**CKF Proof of Evidence on St Edward's School Meadow
(historically known as "The Leasowe"¹)
and now referenced as "land off Oakhurst Rise".**

20 February 2021

Image 1.2: Extract of Drawing 38-1036.03-F rev F 19th May 2020

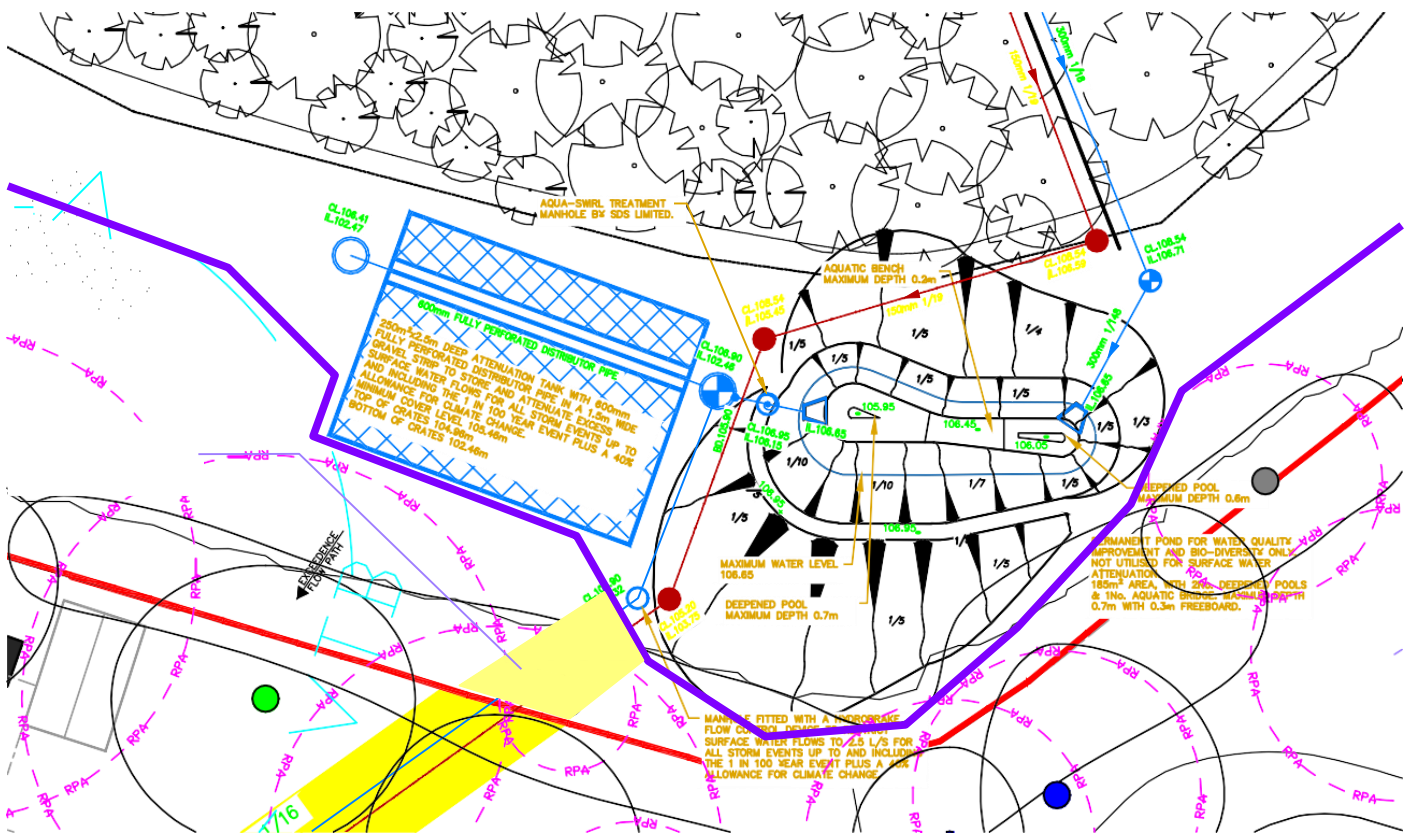
1.7.1 “A layout and form that respects the character, significant and setting of heritage assets”. It is common ground that harm arises to the setting of both heritage assets from this layout and form.

Image 1.3 Extract of Drawing 38-1036.03-F rev F 19th May 2020 including the ‘northernmost school building (Appendix 1.4)

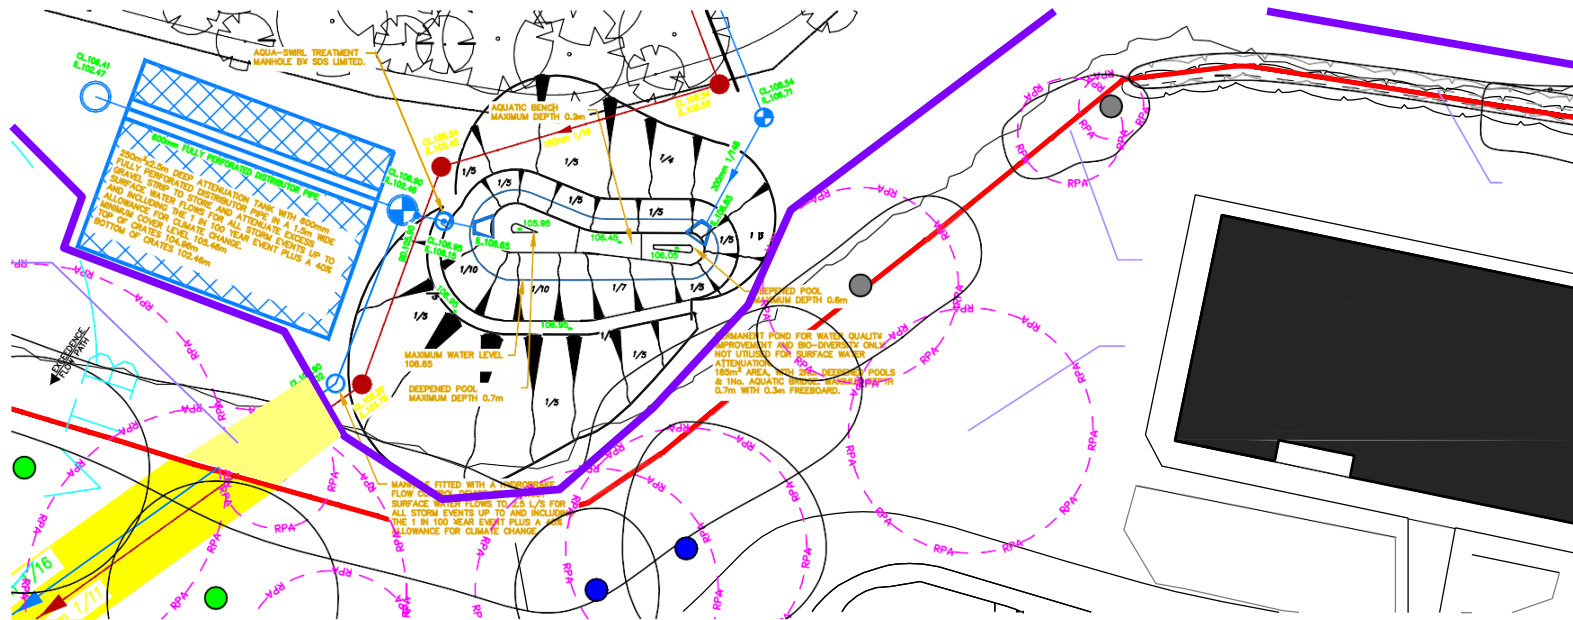
MM016 required “a restriction to the area of the site to ensure that new development does not impact on the setting of adjacent listed buildings³”. The site boundary is in purple, the entrance to a Grade II* listed building is 25.9 metres away, in a south westerly direction.
